Planning/Zoning Application

RE: Site Plan Review for the New Belmark Family Center at 747 Heritage RD
(Parcel ED-F0103-2)

Thank you for the site plan for the new Belmark Family Center at 747 Heritage RD. The City of De Pere staff reviewed the site plan and recommended approval with the following conditions that must be addressed prior to obtaining occupancy permits:

25' ACCESS EASEMENT

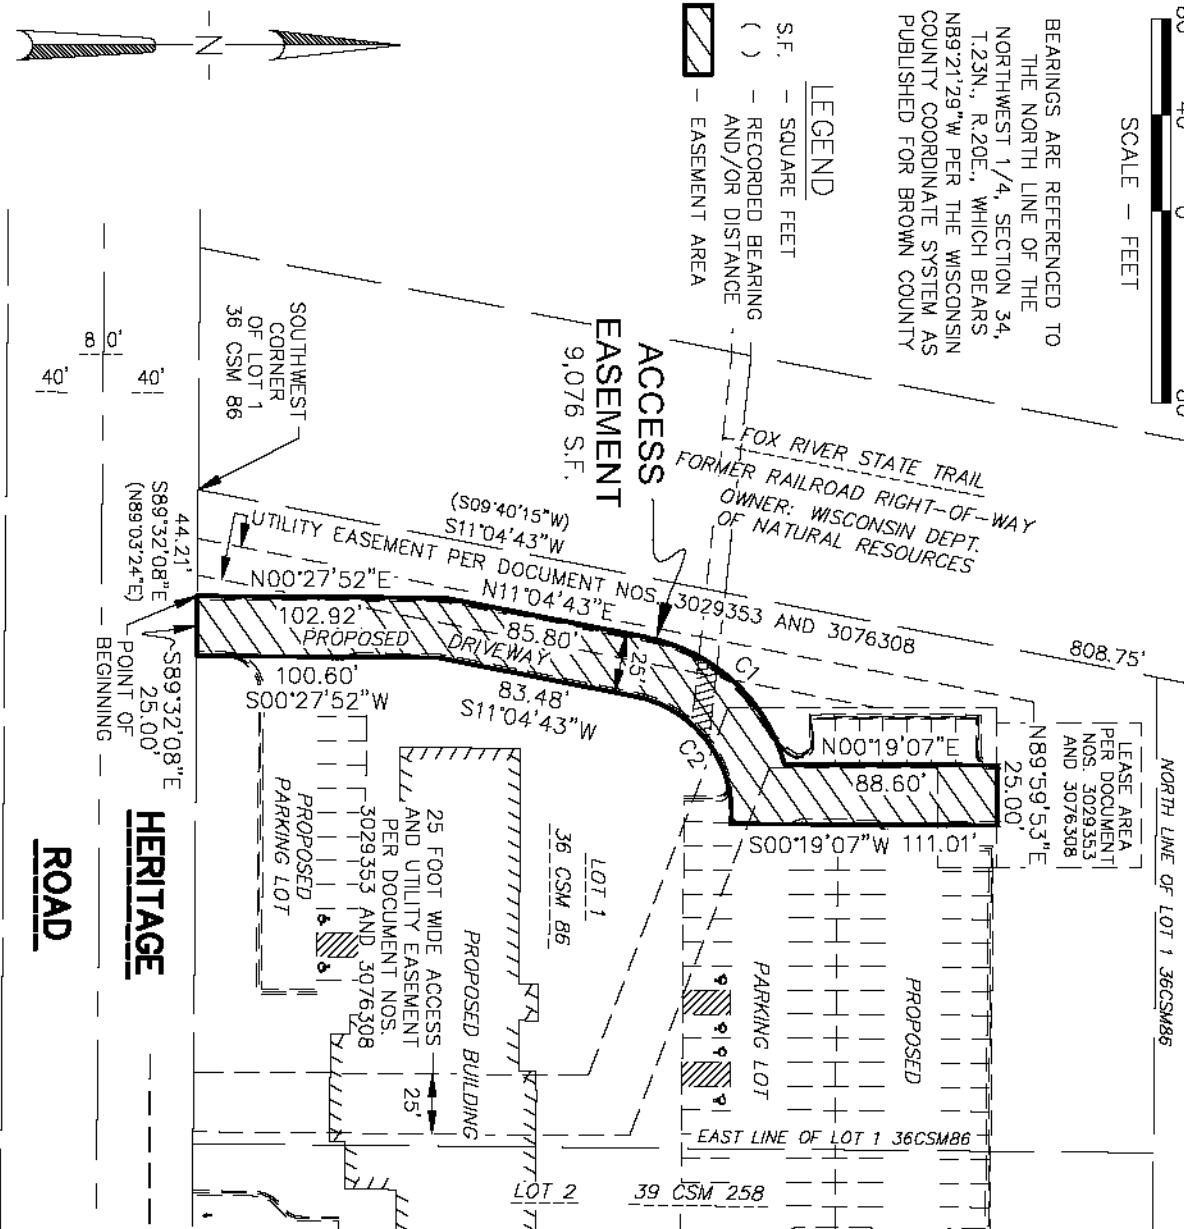
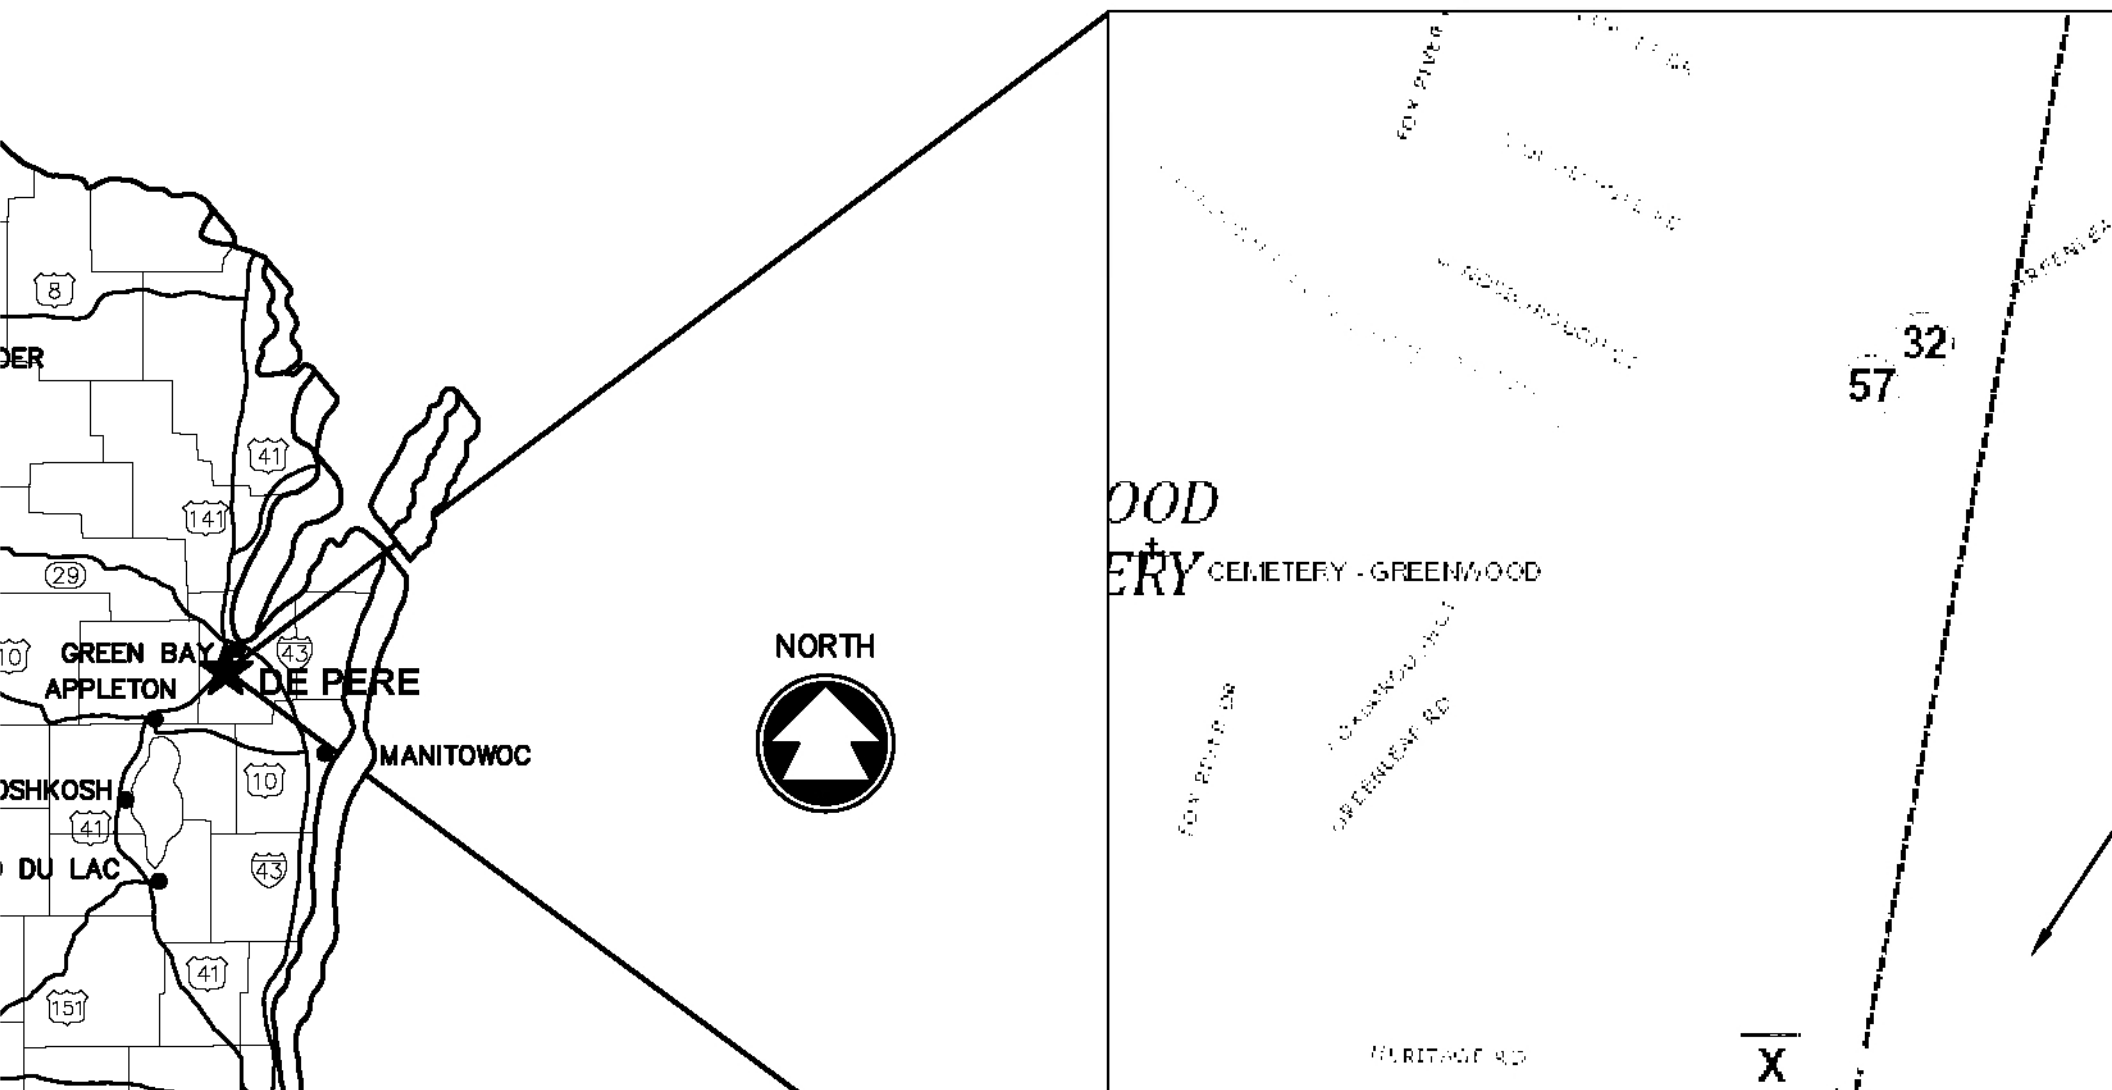
Peta
In reviewing the attached documents. From an operations standpoint. I don't see any issue with the new proposed access route to the tower. Just want to be sure to capture the changes in the GL. Also, will Vertical Bridge be responsible for any of the cost of the access move. I don't believe we should have to help with any cost of the move.

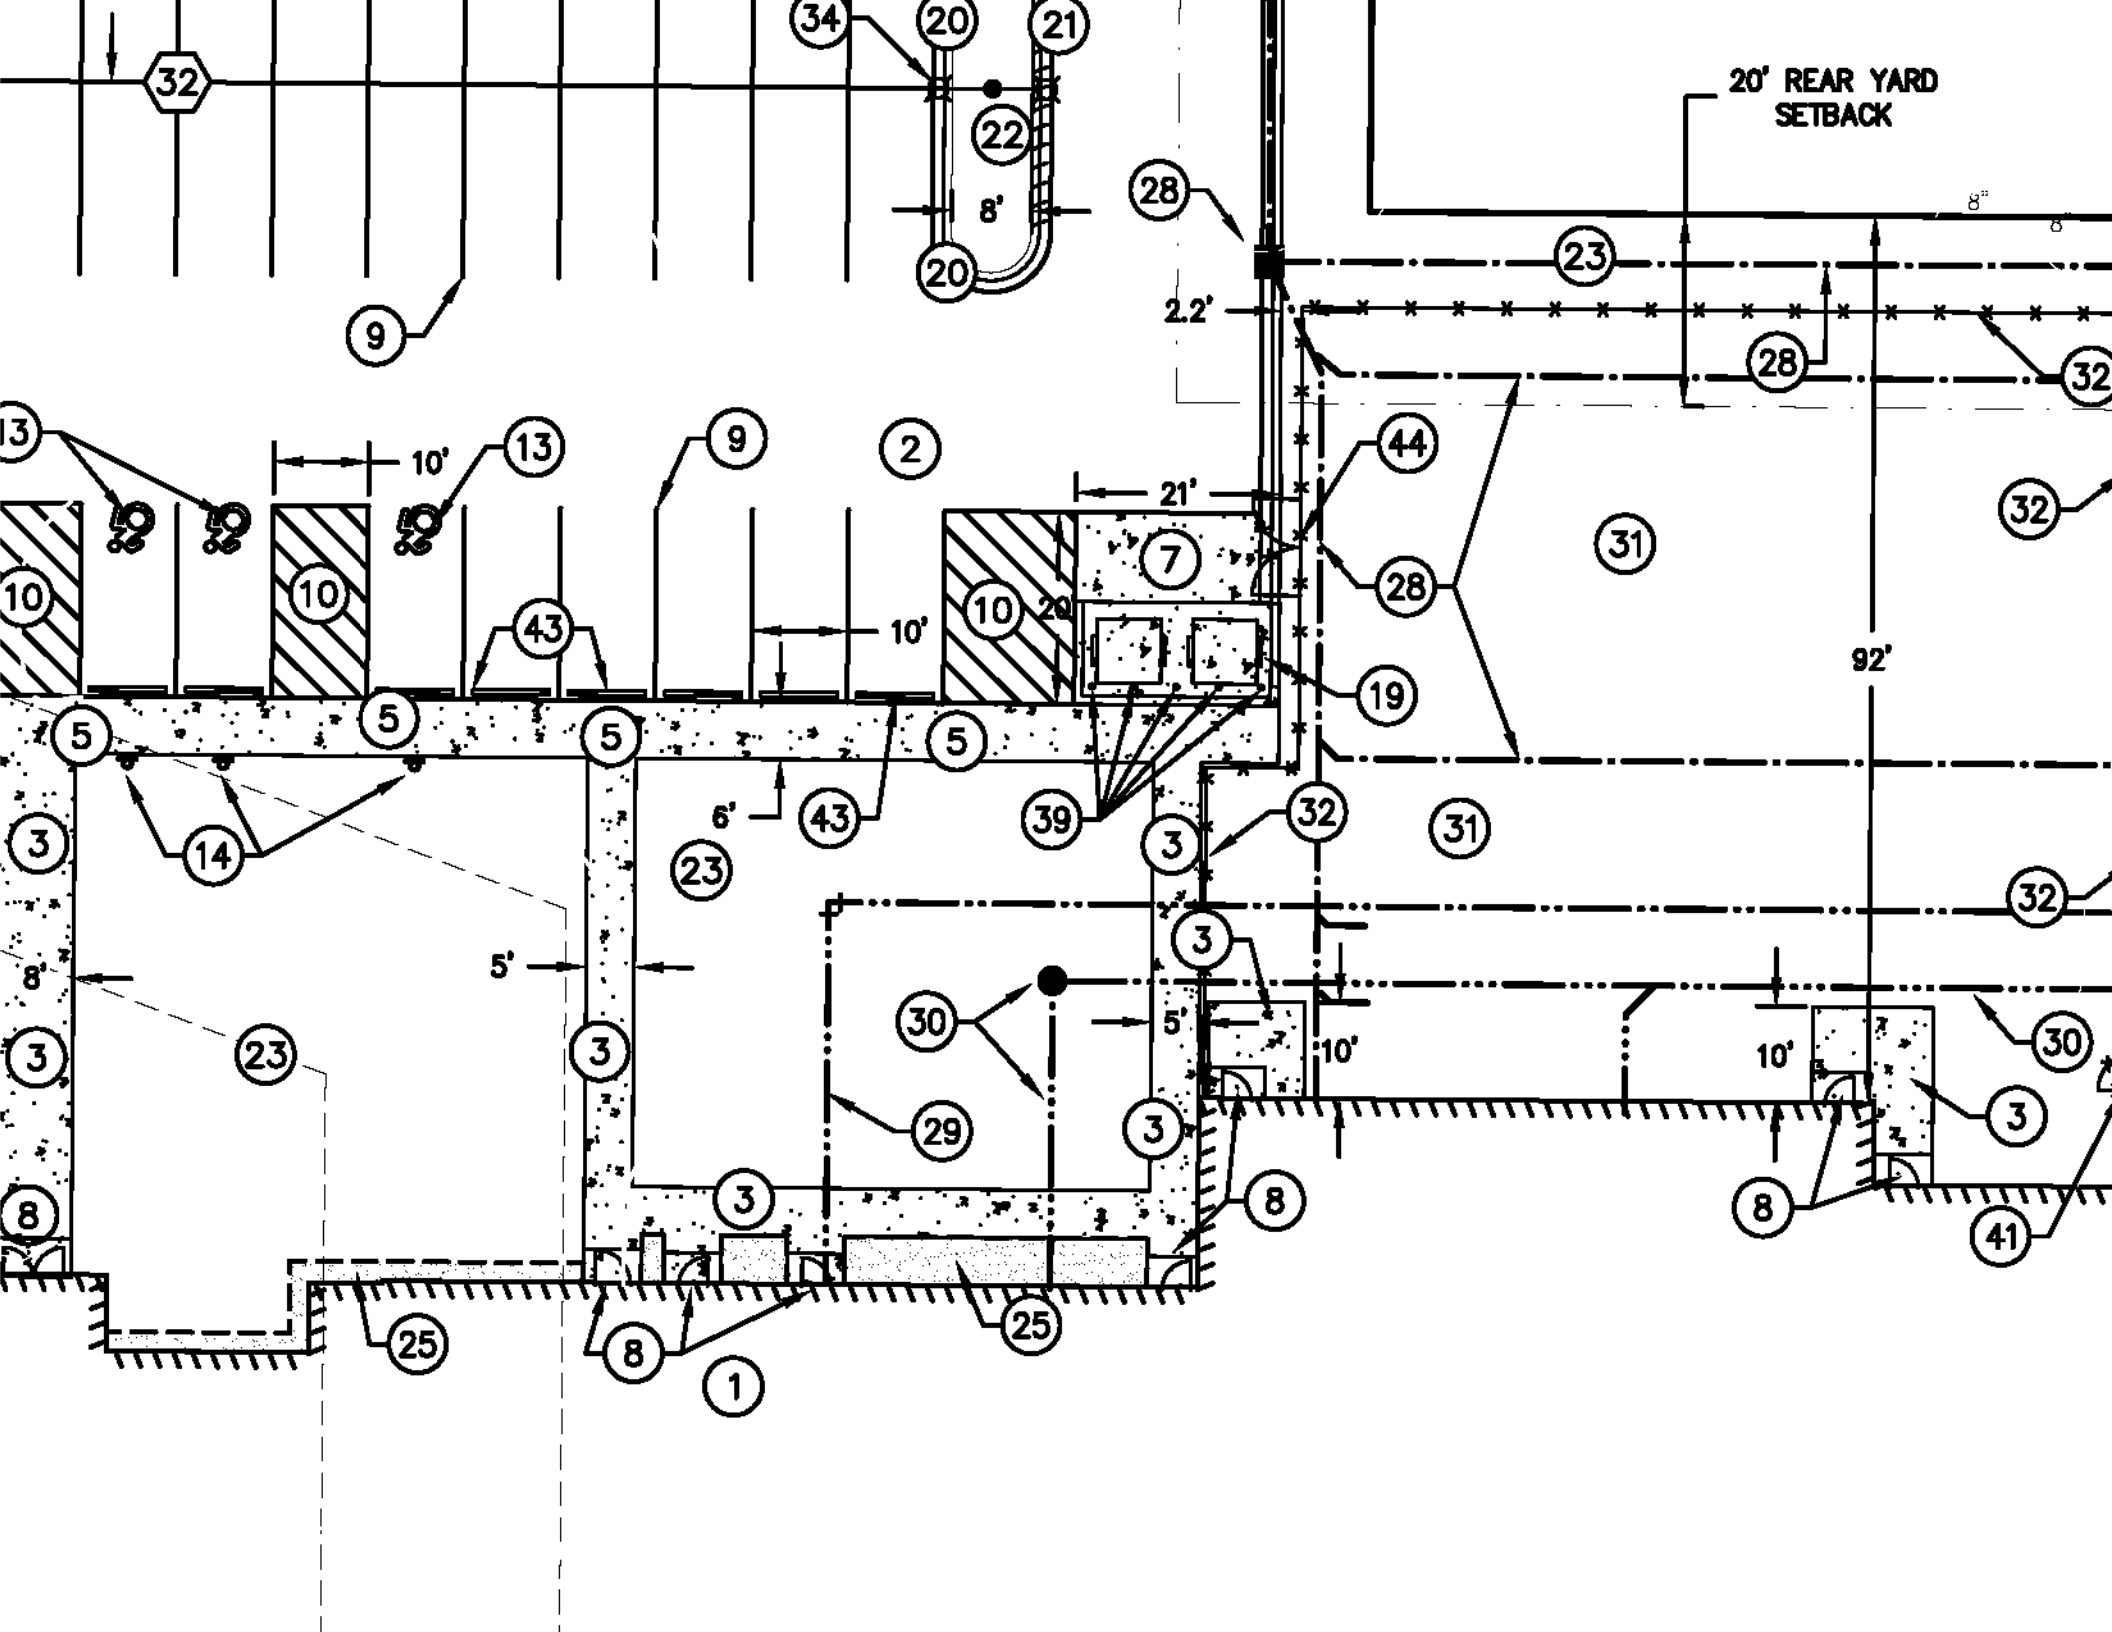
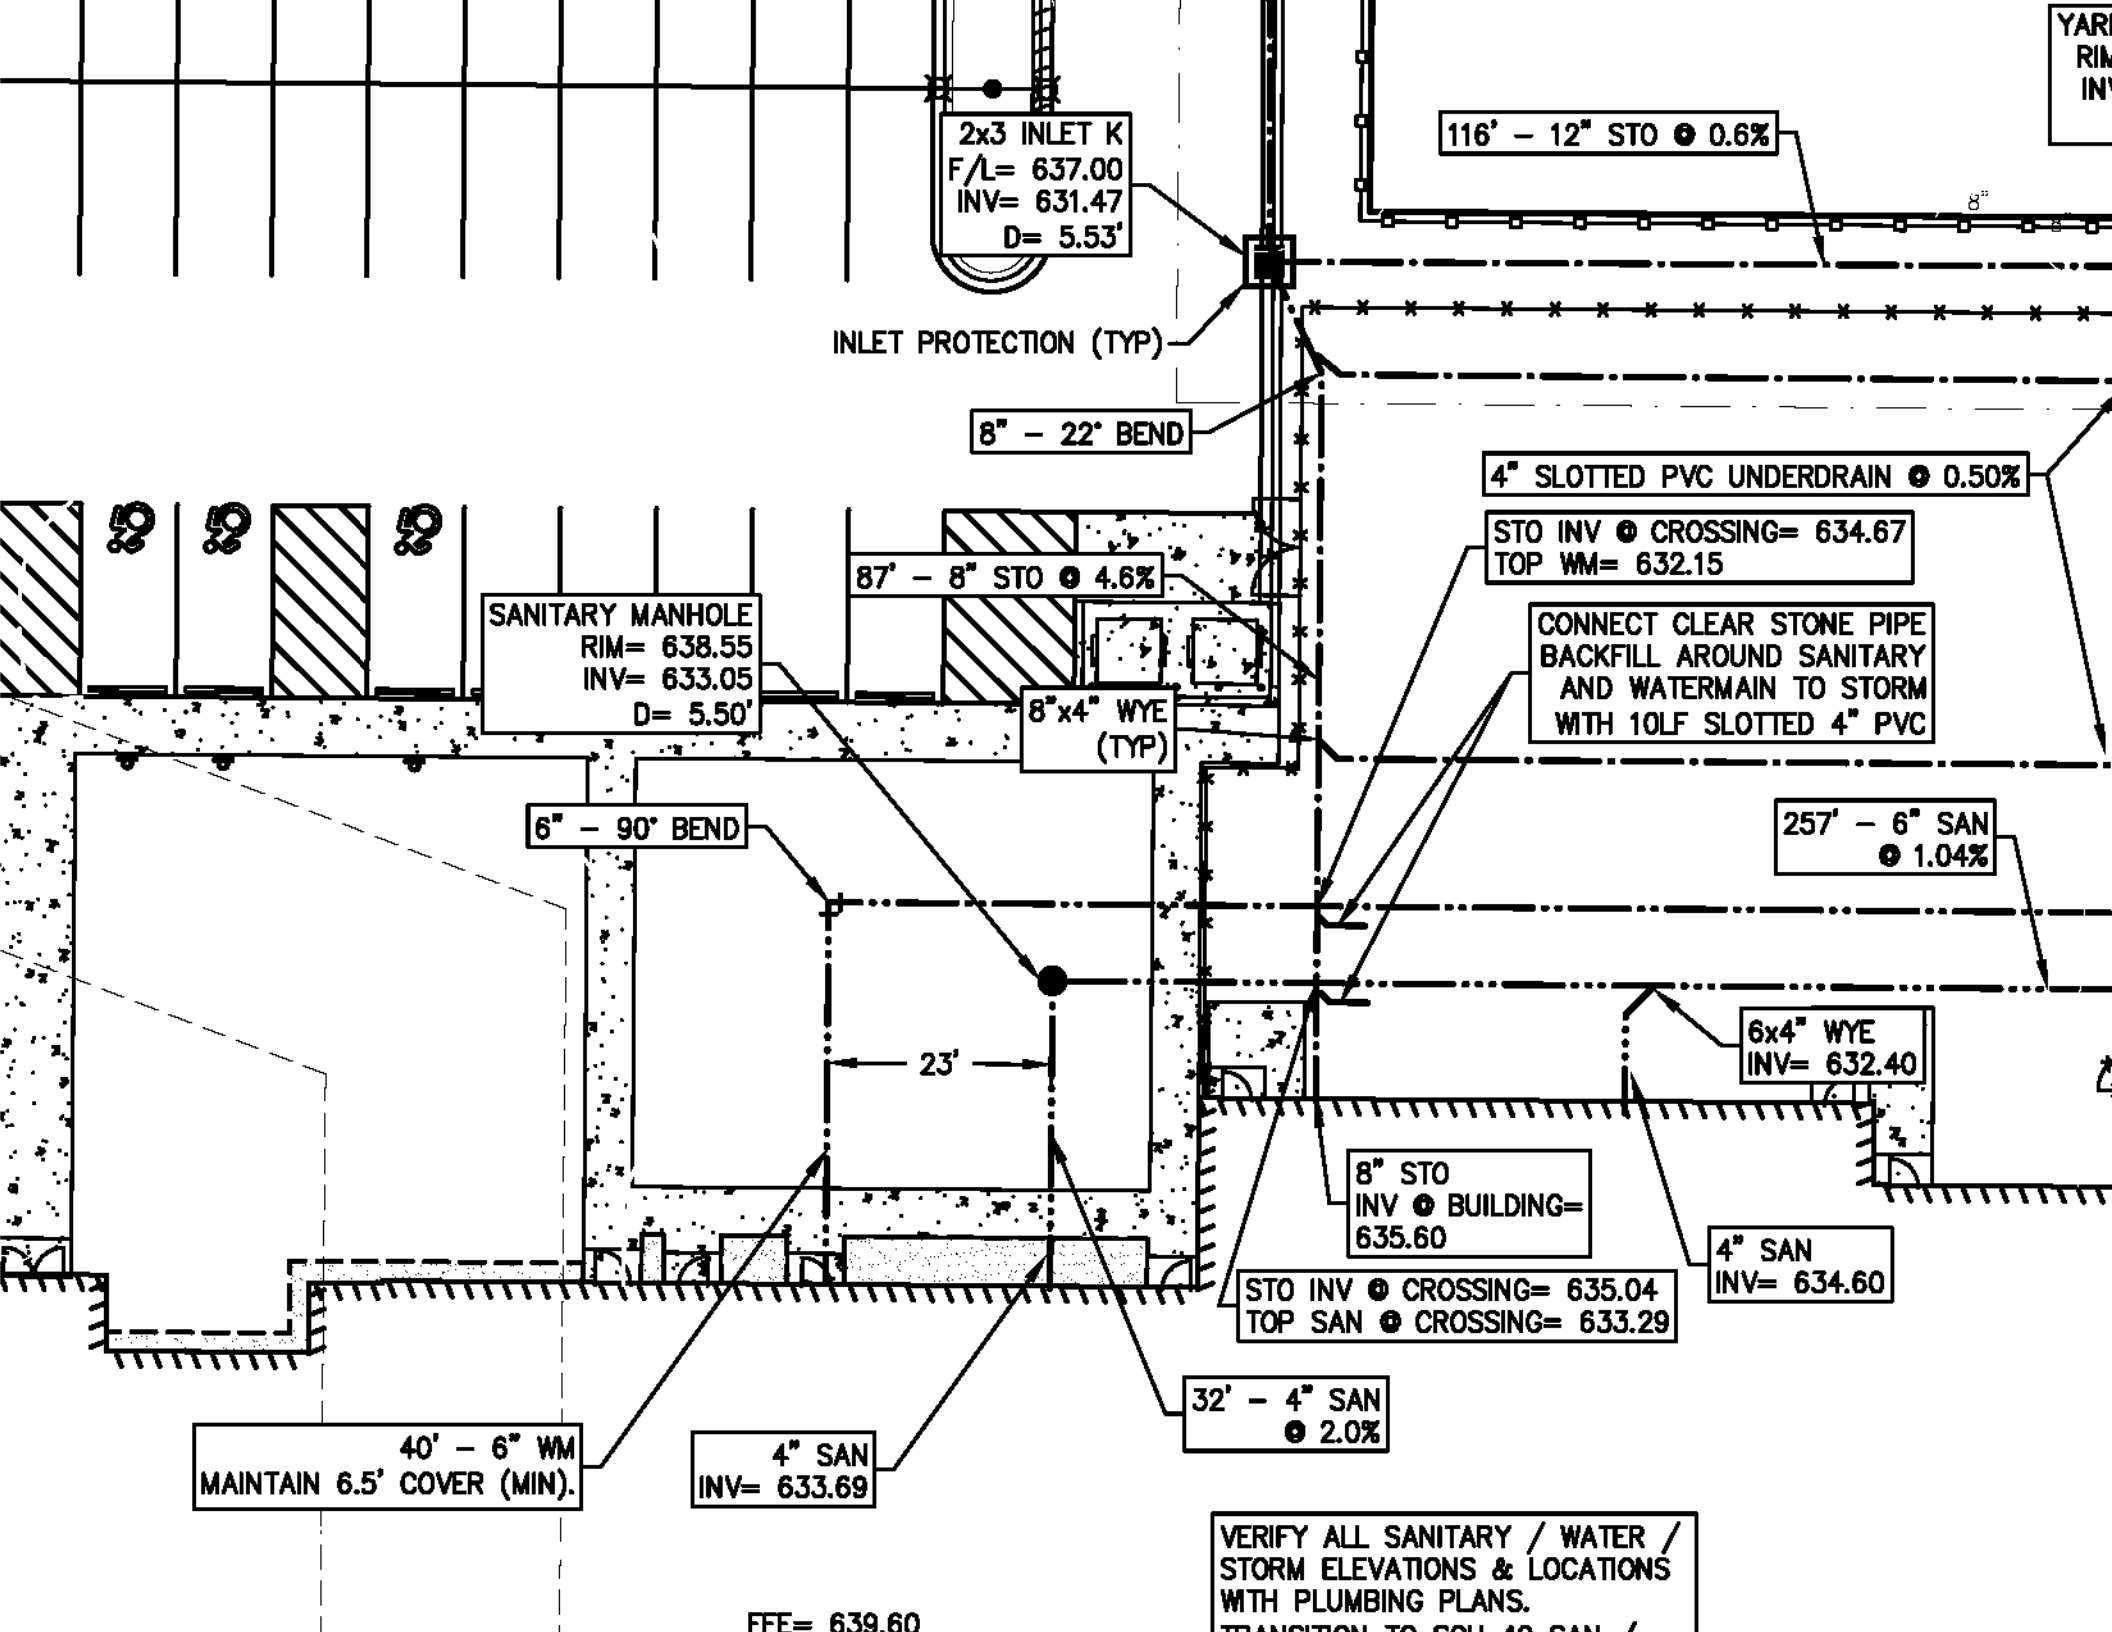
- NOTE: Areas shown in dashes for the future parking lot expansion (including all of Parcel ED-2076) are not part of the site plan review and will need to be resubmitted separately for site plan approval prior to development in the dashed areas.
